PERMIT

SEWAGE DISPOSAL SYSTEM

SUBDIVISION Boka Valley Estates LOT 8 10 ROAD 1815 Boka Valley Court

| <p>Drawn: KBW</p> | <p>PLOT PLAN FOR BUILDING PERMIT BOKA VALLEY SECTION 1 AREA 1 LOT No. 8 4th Election District Howard County, Maryland</p> | <p>Scale: 1" = 50'</p> |

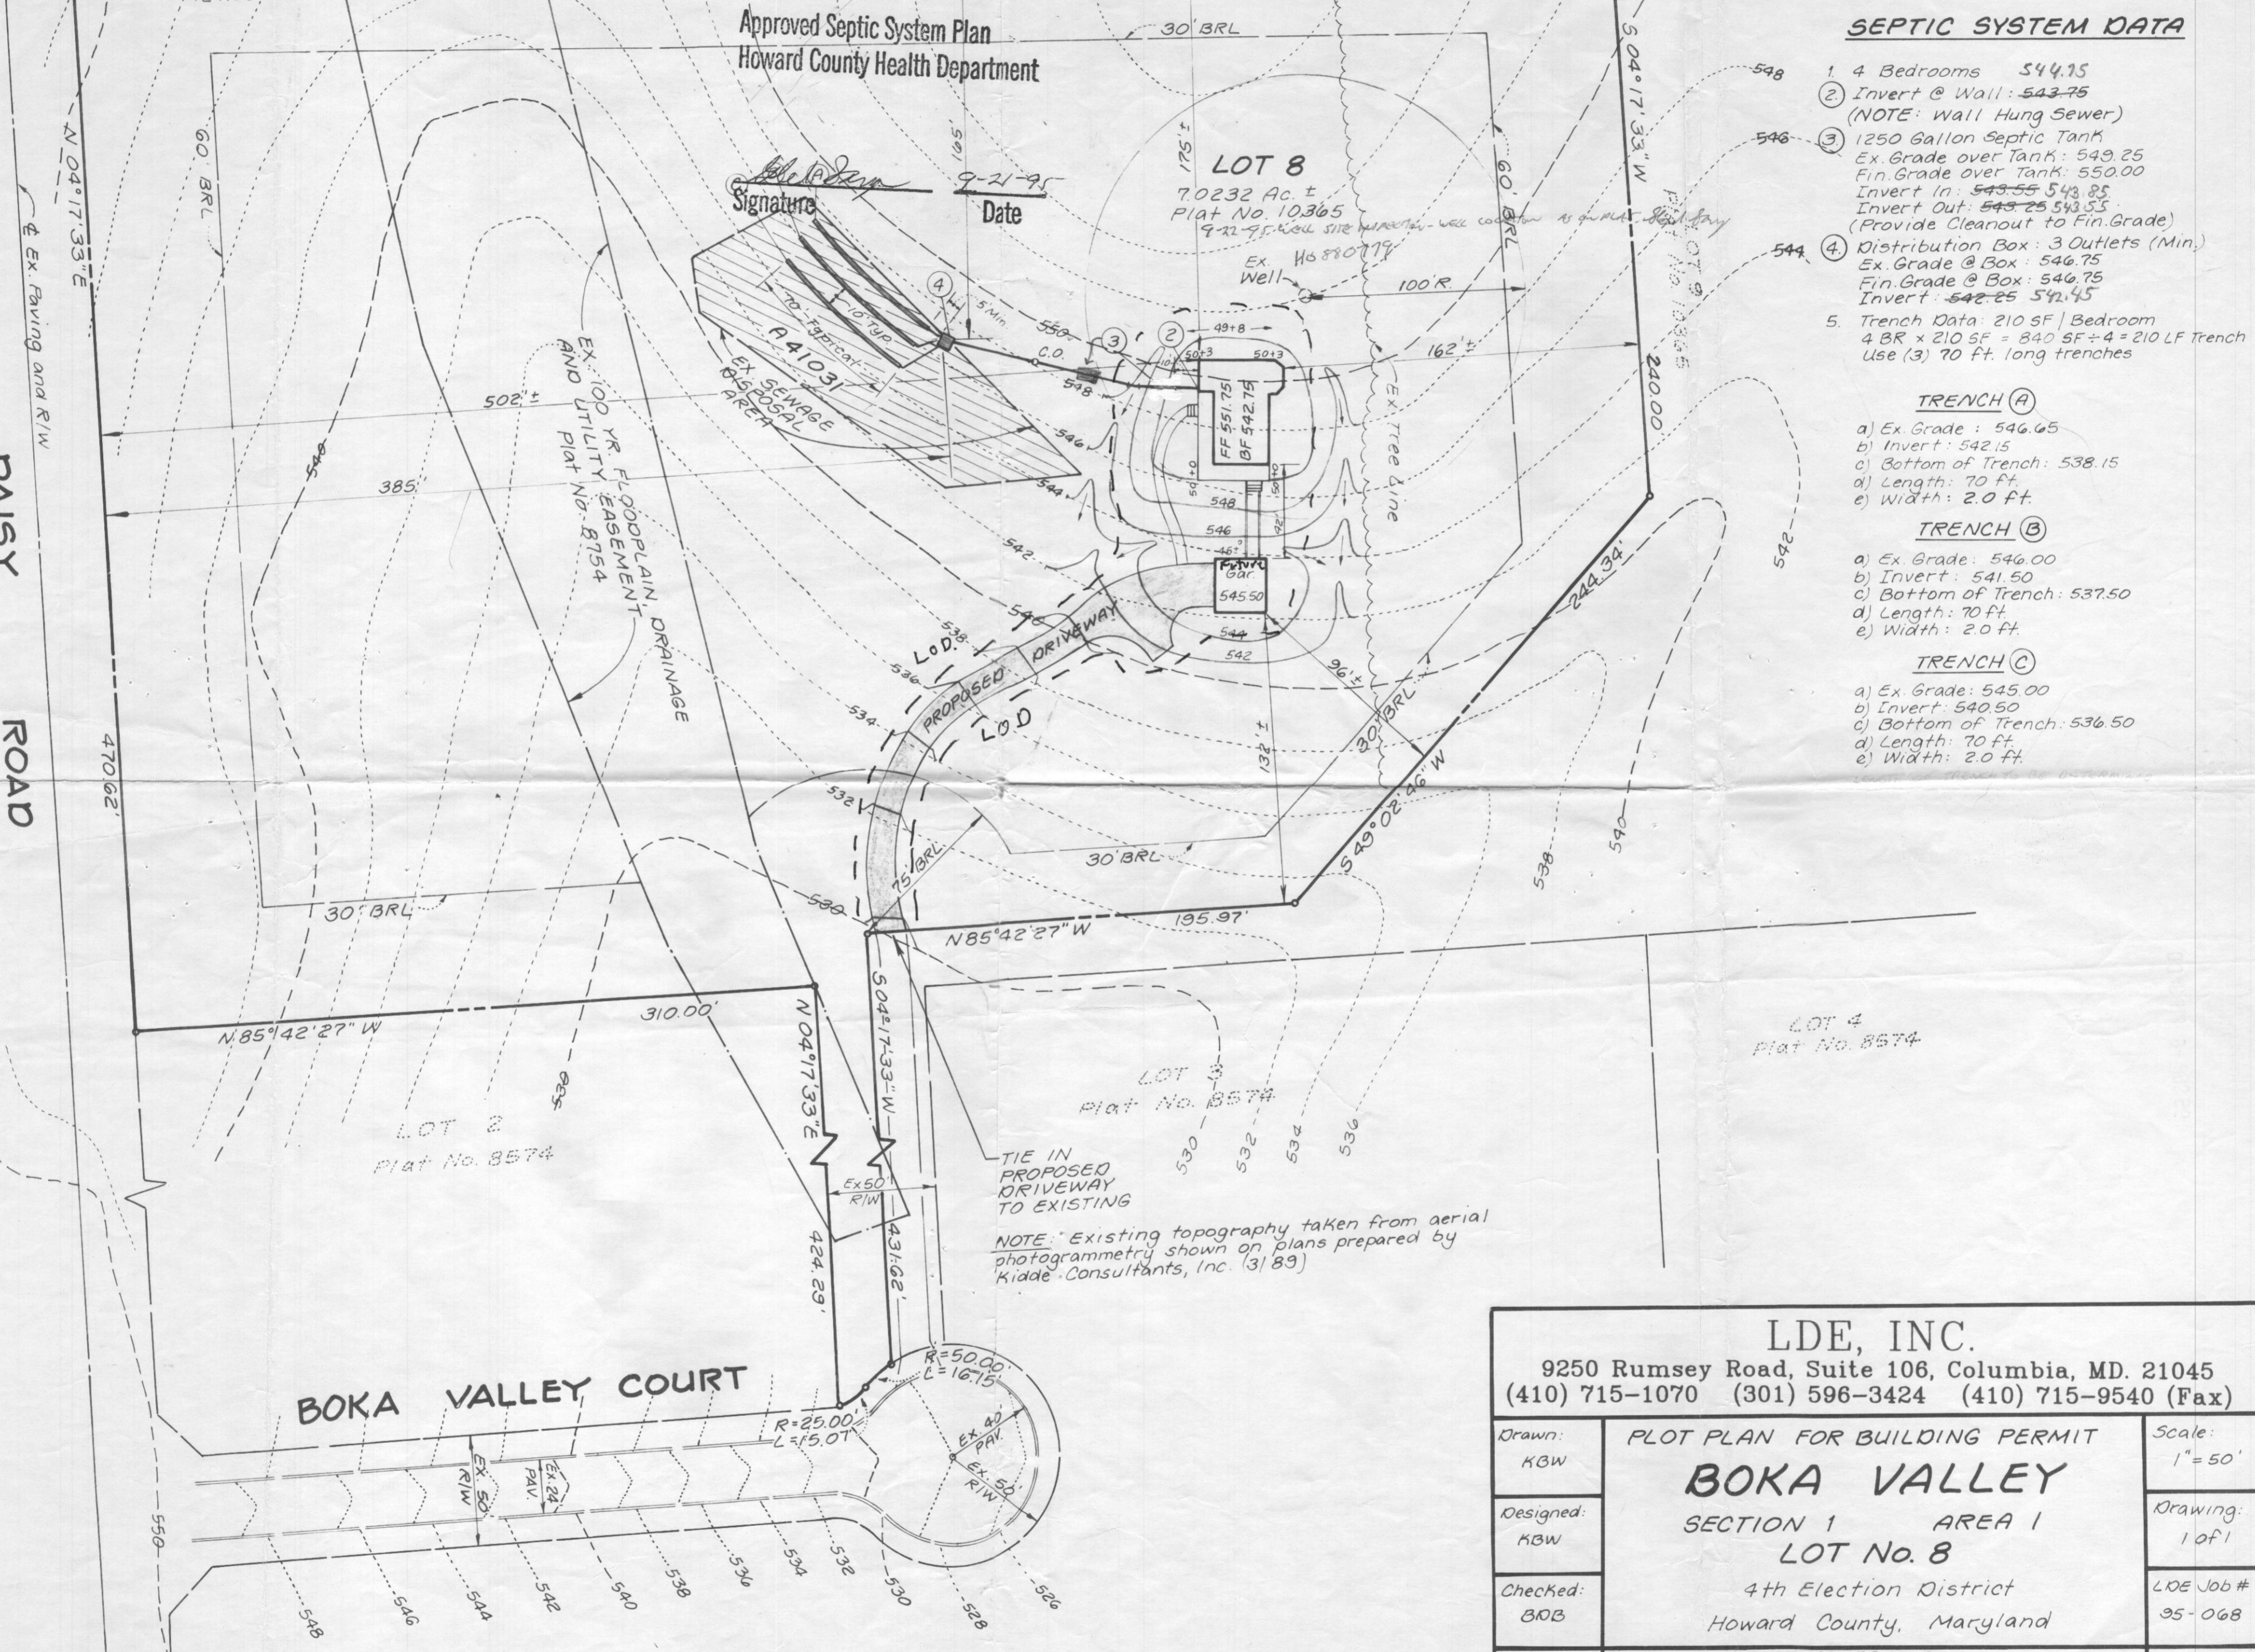
REMARKS: S.T. Hole only 75'± from well - should move to 100'± as per Plan. AP 3/26/96

Soil ok for Mid Sump septic tank 3-29-96 ok to continue - will call for OPEN

4/3/96 OK to cover from 2' off house to d.b. OK to stone

trenches. DKS 4-15-96 HOUSE CONNECTION ok JH

4/4/96 OK to cover all work except 2' off house. Needs house conn.

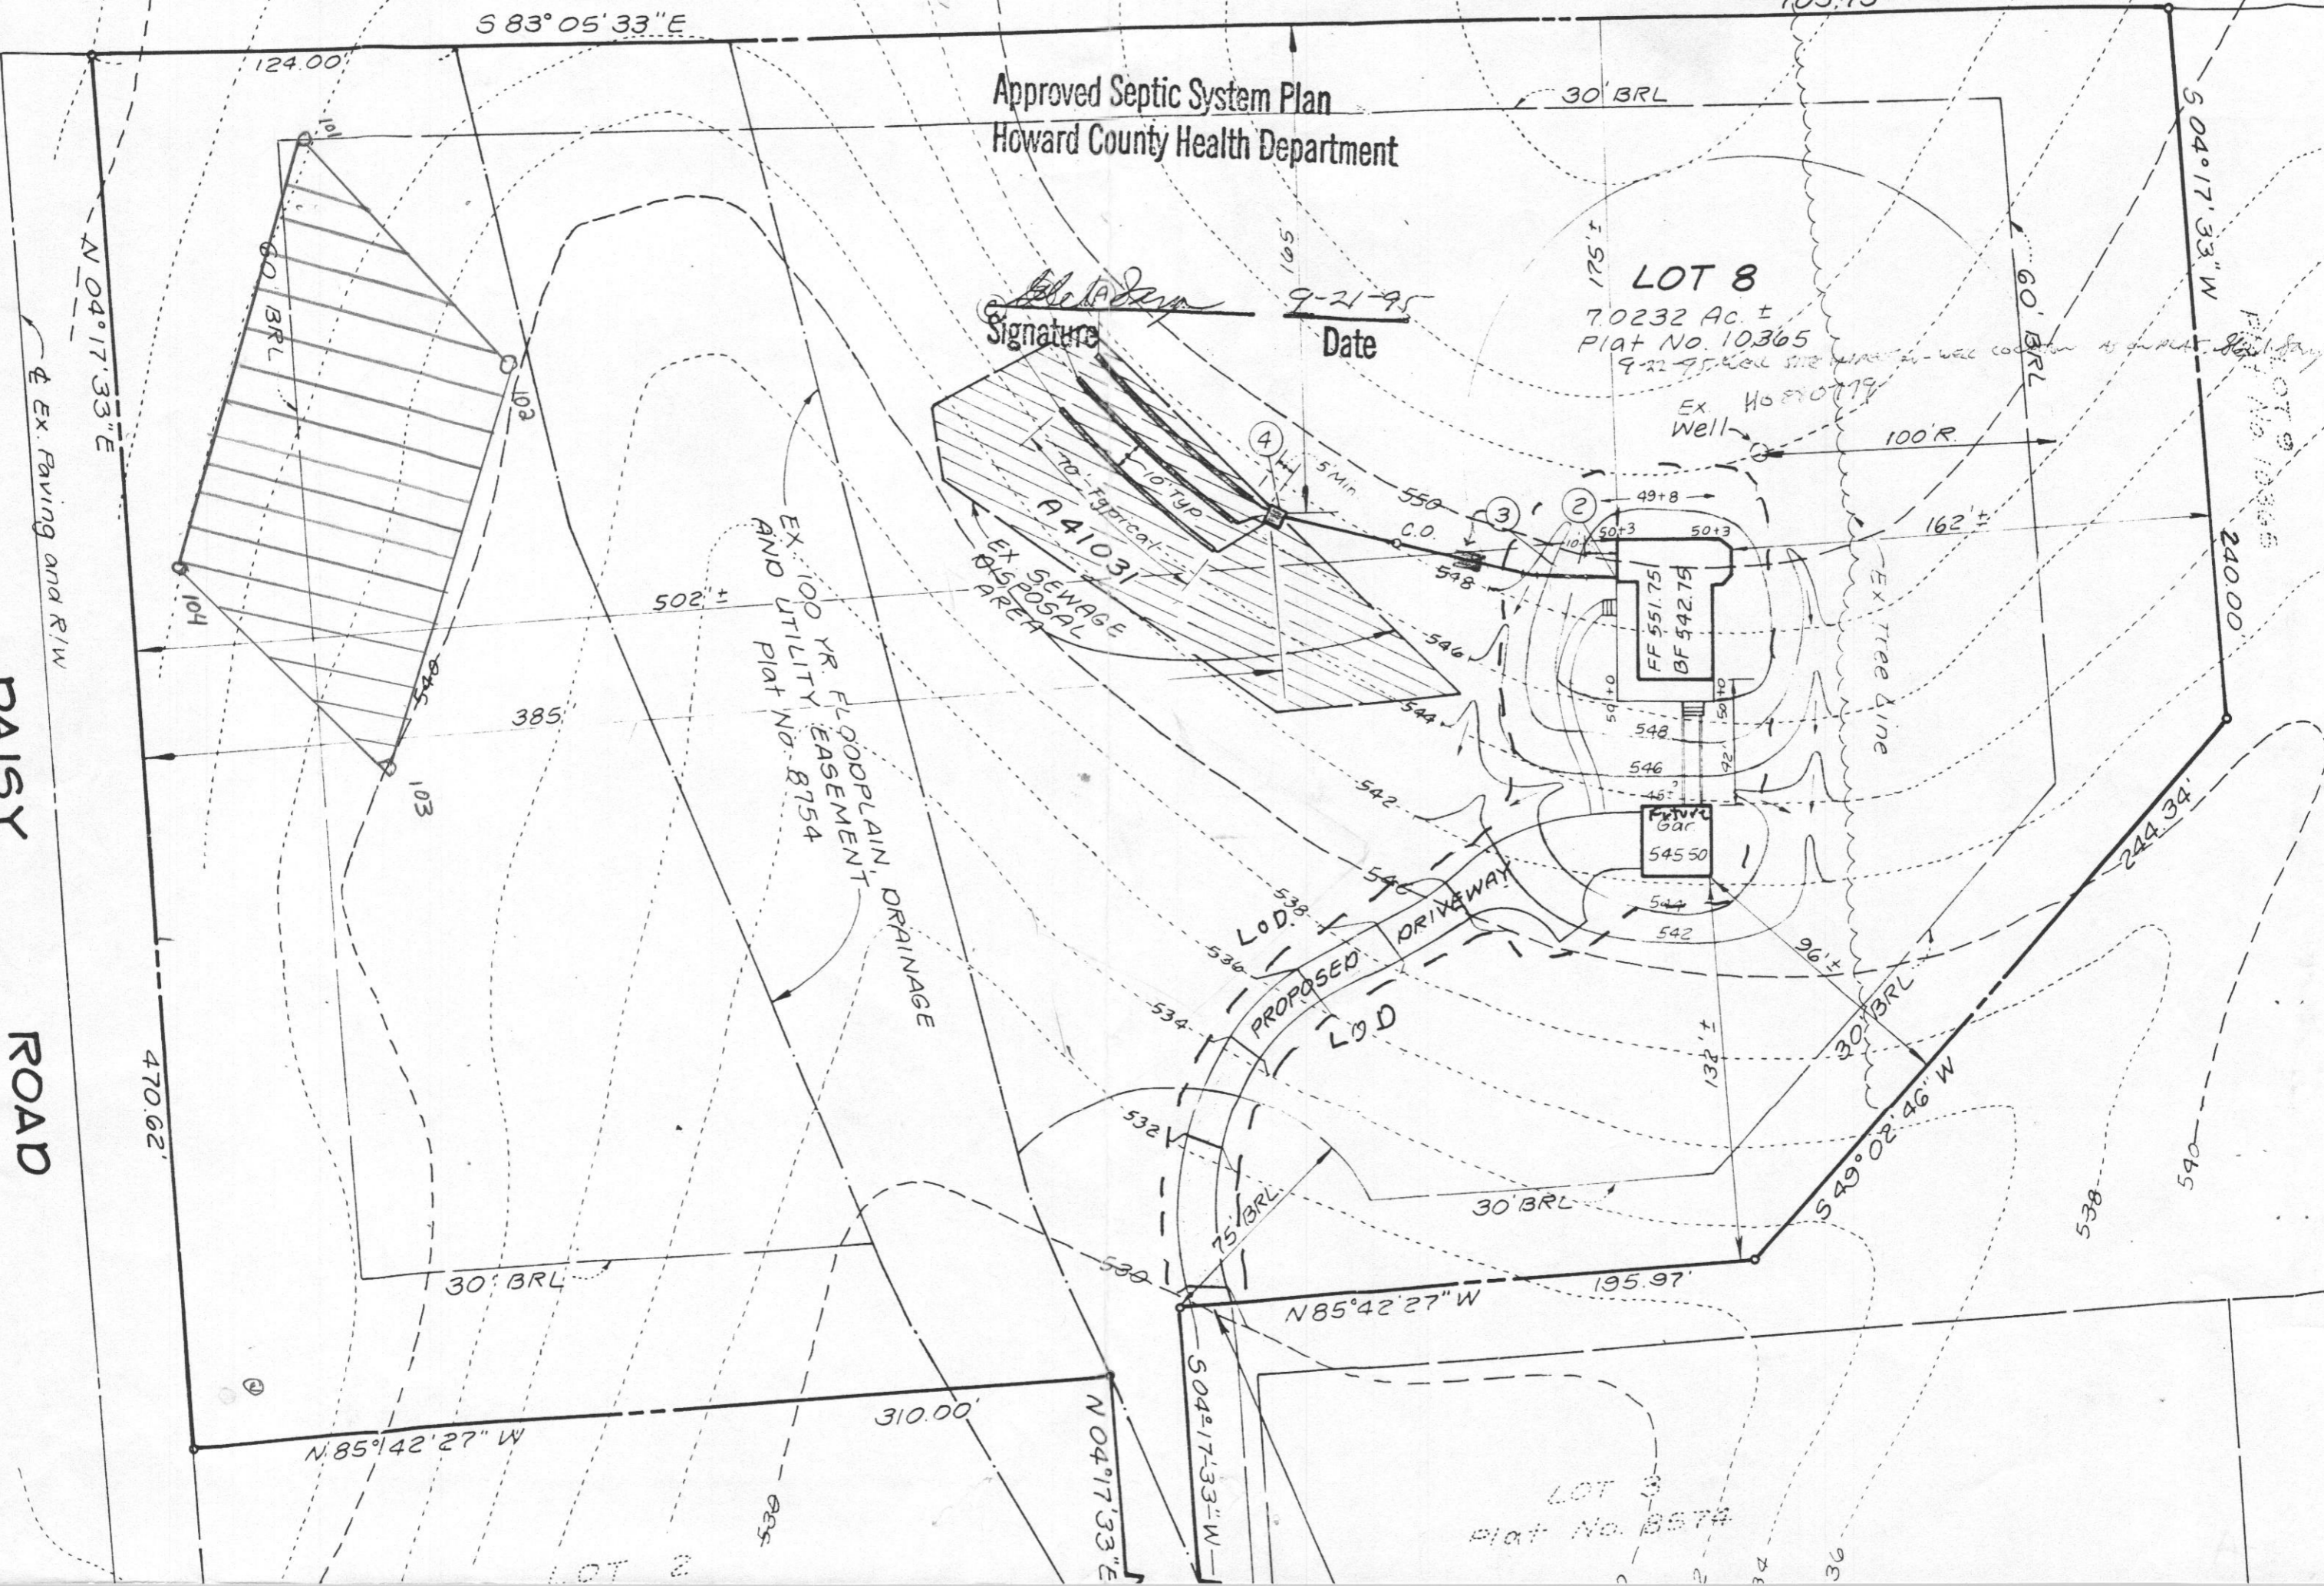
NOTES - No trench to exceed 100 feet in length. Provide 6" - 8" diameter cleanout and cap to grade or above on septic tank. OK 12/8/95 DKS
two 105' long trenches are acceptable (even if slightly out of SDA) RHP 3/29/96
